Subject: BAR Action February 17, 2015 - 501 West Main Street

BAR 14-07-03
501 West Main Street
Tax Parcel 320175000, 320176000, 320177000, and 320178000
The Sutton Group LLC and Andrew Levine, Owner/ Bill Atwood/Southern Cities Studio, Applicant New mixed-use complex construction

CITY OF CHARLOTTESVILLE BOARD OF ARCHITECTURAL REVIEW STAFF REPORT February 17, 2015

BAR 14-07-03
501 West Main Street
Tax parcels 320175000, 320176000, 320177000, and 320178000
The Sutton Group, LLC, and Andrew Levine, Owners/
Southern Cities Studio, Agent, Applicant
New construction - mixed-use complex

W MAIN STREET ELEVATION

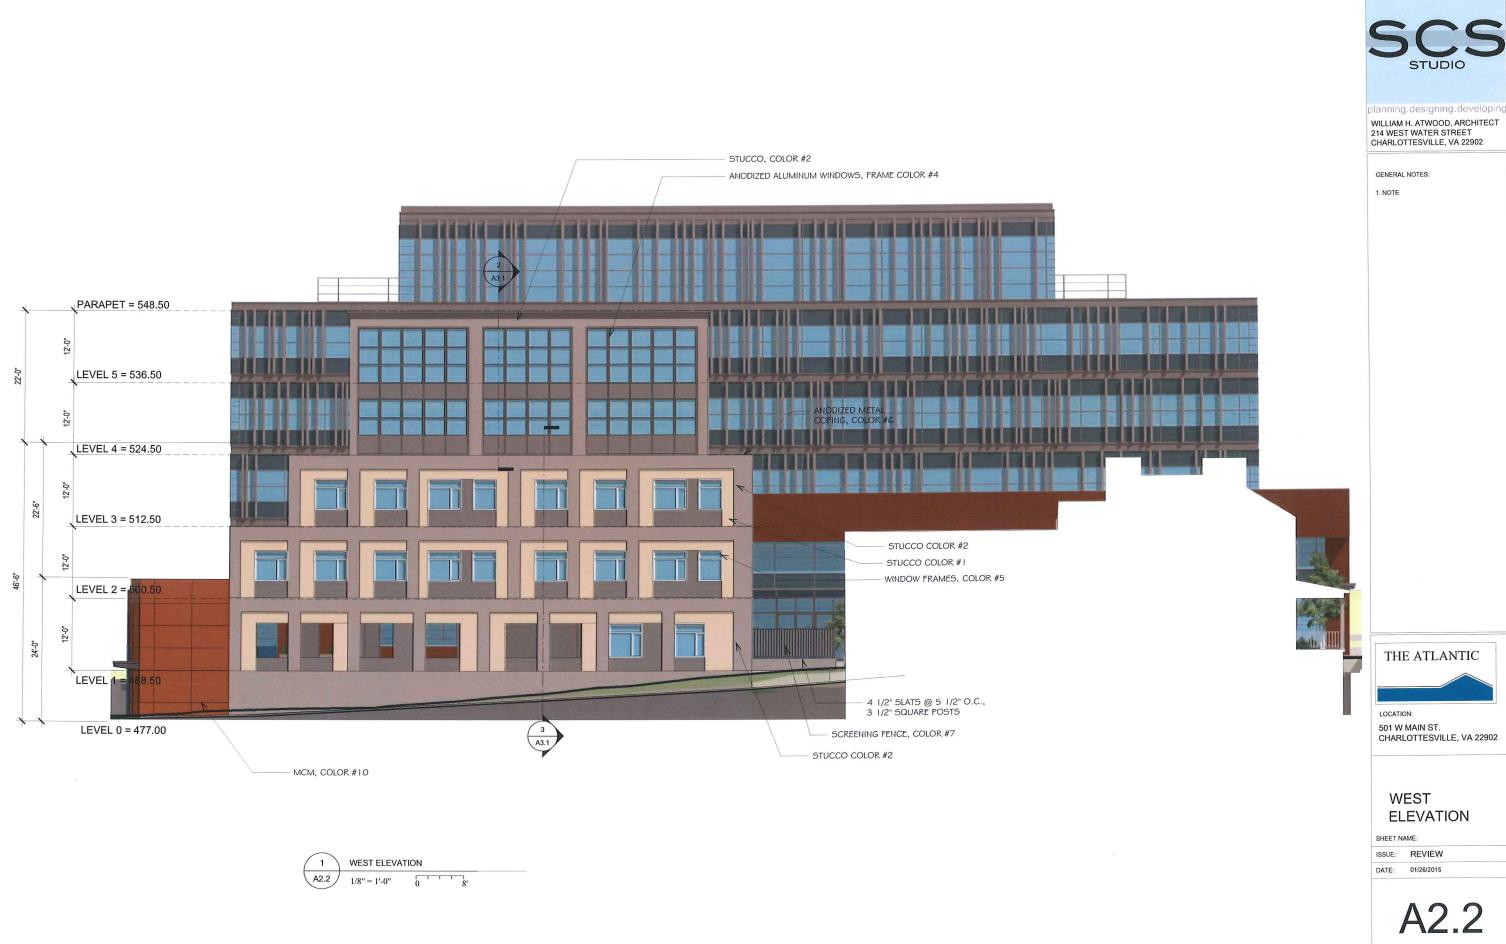
- 1. The exterior skin is not compatible with Commerce Street and West Main Street;
- 2. The scales of the elevations on Commerce Street and some of the details on West Main Street are not compatible with the historic buildings;
- 3. The intermediate levels of the residential block are not compatible with the project and district (The rhythm, patterns and ratio of solid to voids should relate to, and be compatible with adjacent historic facades);
- 4. This was a proposal for a final approval that seemed unresolved.

EAST ELEVATION/ SITE SECTION

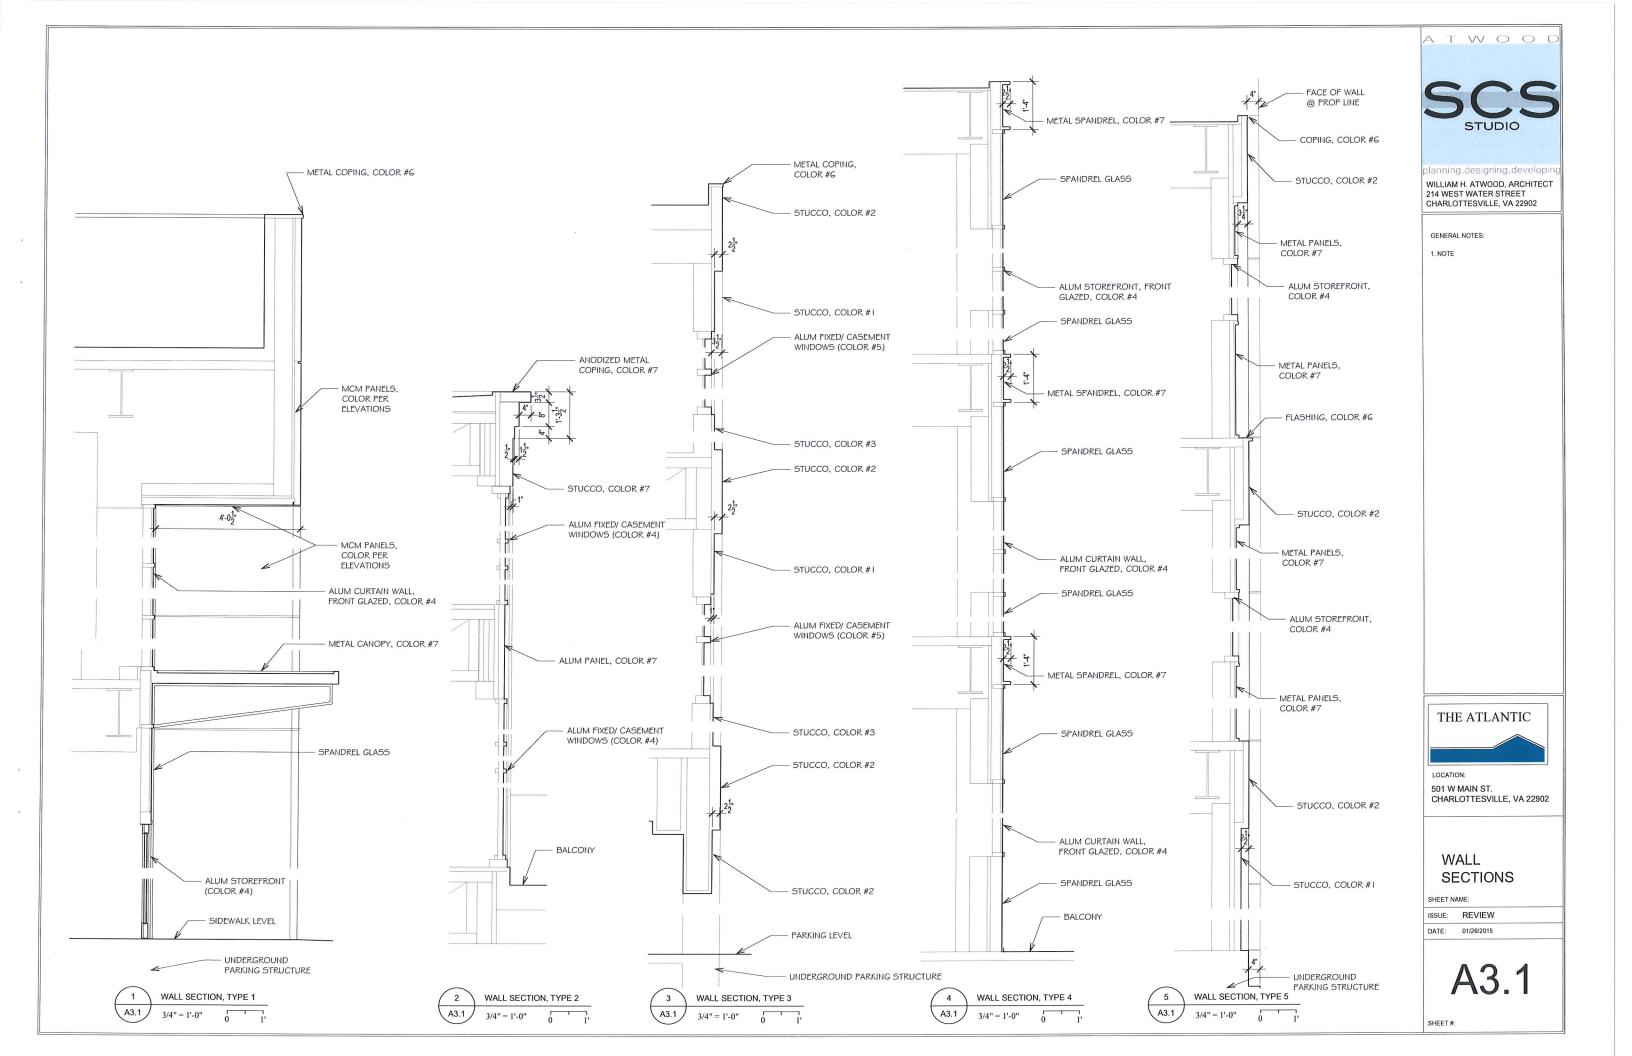
- 1. More details on the landscape plans;
- 2. Reduce the number of materials and colors; make the design more unified;
- 3. Address the fenestration (add more glass) on the east side of the building do not like the "fake" windows" nor the stucco frame around 6 openings;

- 4. Eliminate the different materiality (gray zones) on the center part of both the east and west sides of the office building:
- 5. Make the Commerce Street storefront more current, not dated details, widen the storefront windows, there is disconnect between glass /steel buildings and faux 19th c. storefronts below; brick is fine but simplify materials; the massing and scale are correct on Commerce Street but needs to be unified;
